Staff Report to the Board of Trustees

Weber Grill Restaurant – Downtown Orland Park Parcel H

Project: 2025-0574 Weber Grill Restaurant – Downtown Orland Park Parcel H

SITE PLAN

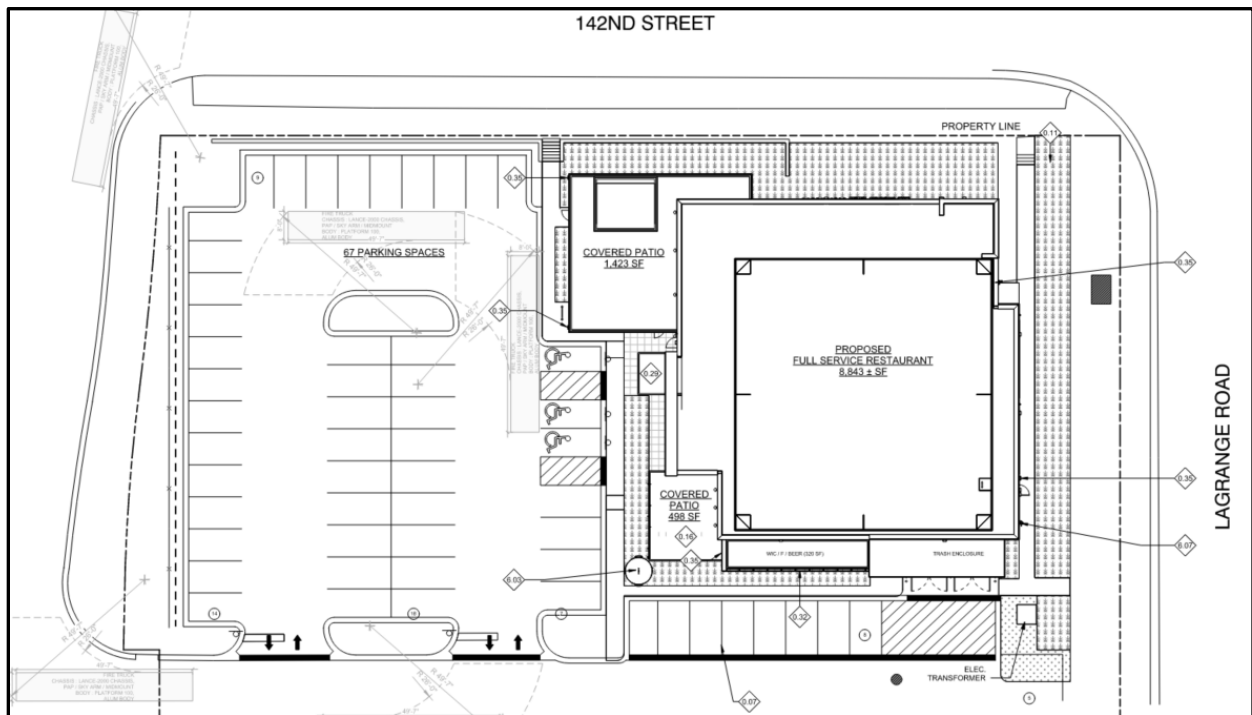
Parcel H is bounded by 142nd Street to the north, University of Chicago Center for Advanced Care (UCMC) to the south, LaGrange Road to the east, and Jefferson Avenue to the west. The proposed building consists of an 8,843 square-foot restaurant space with just under 2,000 square-feet of outdoor patio space.

Parcel H shares an existing shared driveway with UCMC located on Jefferson Avenue. Pedestrian access is provided from 142nd Street to the north and directly from LaGrange Road to the east. Internal sidewalks are proposed around the entire parcel, except for the vehicle entrance on Jefferson Avenue. The parking lot for Parcel H is designed as an extension of the existing UCMC parking lot. All proposed setbacks follow Village requirements. A modification allowing parking within the setback area between the building façade and the street (Section 6-212.E.2) was previously granted for this parcel as part of the overall concept plan approval (Ord. No. 5927).

The proposed Weber Grill site plan is in substantial conformance with the Village Board approved site plan for Parcel H, which was approved on August 5, 2024. In accordance with the Development Agreement and conditions outlined in Special Use Ordinance No. 5927, the project does not require additional Plan Commission review.

The Land Development Code (LDC) requires restaurants to provide one parking space per 100 square feet of tenant space. Based on the proposed 8,843-square-foot Weber Grill, 88 parking spaces are required; however, only 67 spaces are provided on site. Within the VCD District, shared parking is permitted and encouraged. Additional parking for the restaurant is available in the UCMC lot located south of the building and in the parking garage on Parcel F. The Walker Consultants parking study, last revised July 16, 2024, supporting the Downtown Orland Park Concept Plan, identified shared parking arrangements for the overall planned development and demonstrates that enough capacity exists to accommodate Weber Grill at this location.
